CAUI-4 Sinusoidal Jitter Specification: Additional requirements?

Vinu Arumugham, Cisco

Figure 13-12. Host input and Module input Sinusoidal Jitter

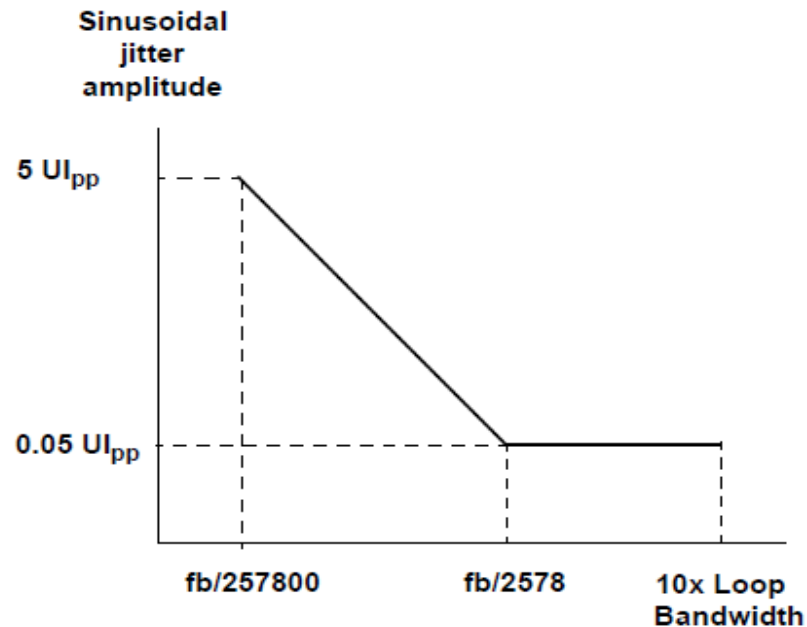
1. For a complete spec., an RX SJ tolerance spec. should be paired with a TX SJ generation spec.

Currently most specifications including CAUI-4 do not directly specify TX SJ. It is therefore possible for a compliant TX to exceed the RX SJ tolerance spec.

2. For applications with multiple interconnect segments, devices need to be specified to be either SJ transparent or SJ terminating

CAUI-4 chip-chip and chip-module specifications, do not specify SJ handling

With SJ transparent devices, SJ accumulates at every device between ASIC TX and ASIC RX.

Sinusoidal Jitter Accumulation

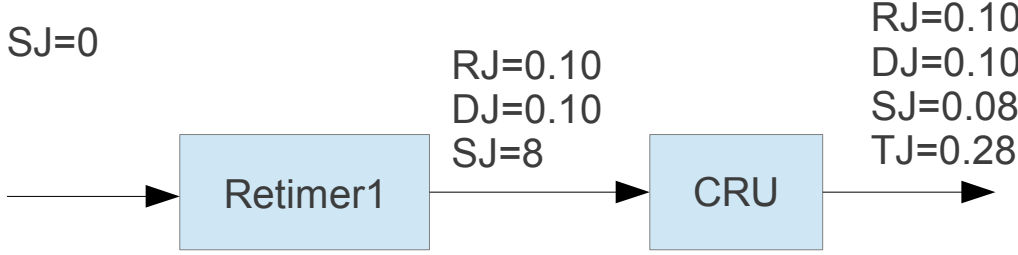
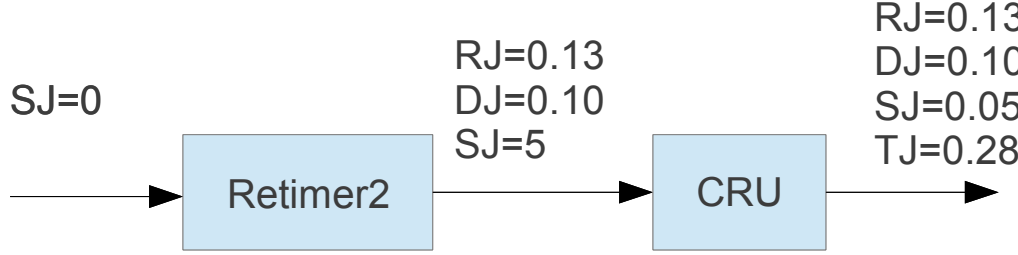
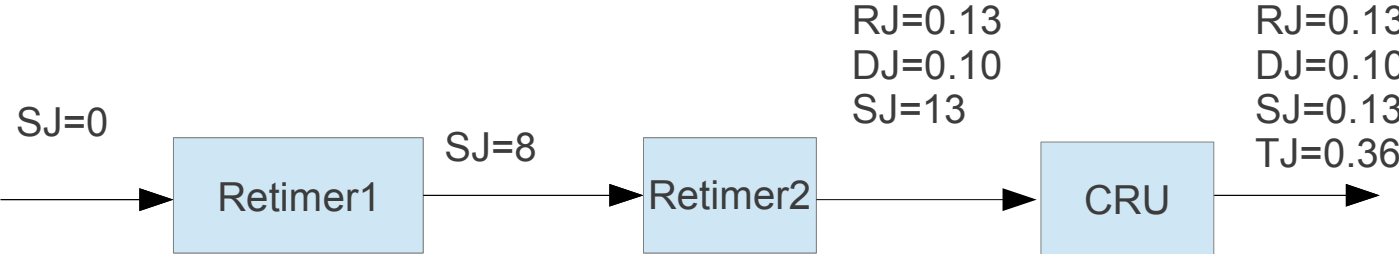
Assume SJ Frequency is $F_b/257800 = 100\text{KHz}$
 All jitter in Upp

Compliant TX exceeds RX SJ Tolerance limit

Compliant devices cascaded result in non-compliant output
